<b>Title - Sujet</b> WRI office fitup project	
<b>Solicitation No. - N° de l'invitation</b> E62ZR-212805/A	<b>Amendment No. - N° modif.</b> 005
<b>Client Reference No. - N° de référence du client</b> 20212805	<b>Date</b> 2021-10-12
<b>GETS Reference No. - N° de référence de SEAG</b> PW-\$\$HN-331-80357	
<b>File No. - N° de dossier</b> hn331.E62ZR-212805	<b>CCC No./N° CCC - FMS No./N° VME</b>
<b>Solicitation Closes - L'invitation prend fin</b> <b>at - à 02:00 PM</b> Eastern Daylight Saving Time EDT <b>on - le 2021-10-25</b> Heure Avancée de l'Est HAE	
<b>F.O.B. - F.A.B.</b> <b>Plant-Usine:</b> <input type="checkbox"/> <b>Destination:</b> <input checked="" type="checkbox"/> <b>Other-Autre:</b> <input type="checkbox"/>	
<b>Address Enquiries to: - Adresser toutes questions à:</b> Turner, Louie	<b>Buyer Id - Id de l'acheteur</b> hn331
<b>Telephone No. - N° de téléphone</b> (613) 297-3769 ( )	<b>FAX No. - N° de FAX</b> ( ) -

**Solicitation amendment 005 is issued to answer potential bidders' questions, to remove Clickshare units in room type 7 and to update appendix A – Room List.**

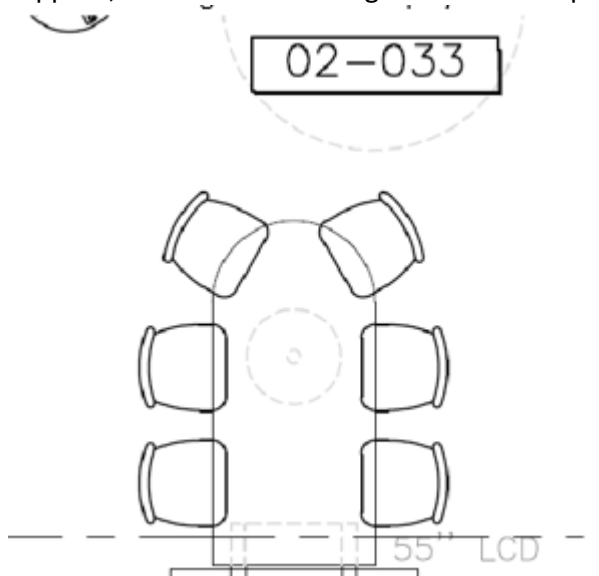
Type 1.1 – Work Room A – the written BoM and description state a 43" display are to be supplied, however the drawings show a 55" display. Please advise as to the correct size required.

The drawings supplied were those of the Designer and what they assumed would be present in the space at the time of the layout design, the Room List is and remains the true source of desired products; therefore, room 02-033 requires a 43" display.

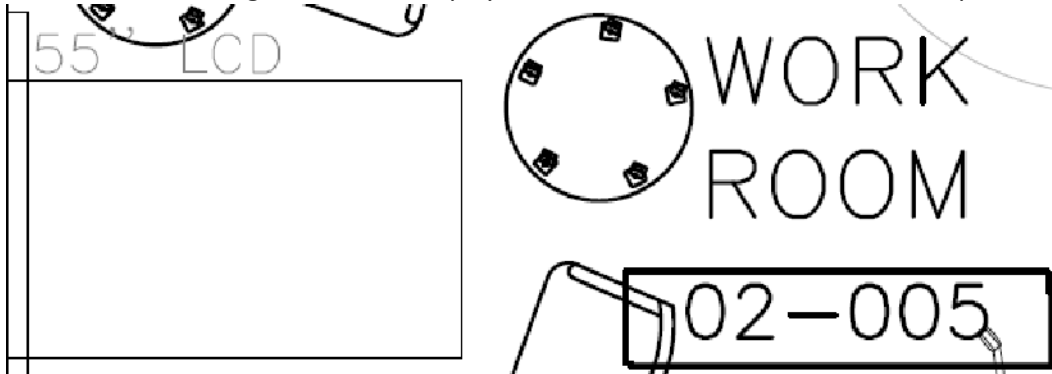
Type 1.2 – Work Room B - the written BoM and description state a 43" display is to be supplied, however the drawings show a 55" display. Please advise as to the correct size required.

The drawings supplied were those of the Designer and what they assumed would be present in the space at the time of the layout design, the Room List is and remains the true source of desired products; therefore, all rooms of type Work Room B require a 43" display.
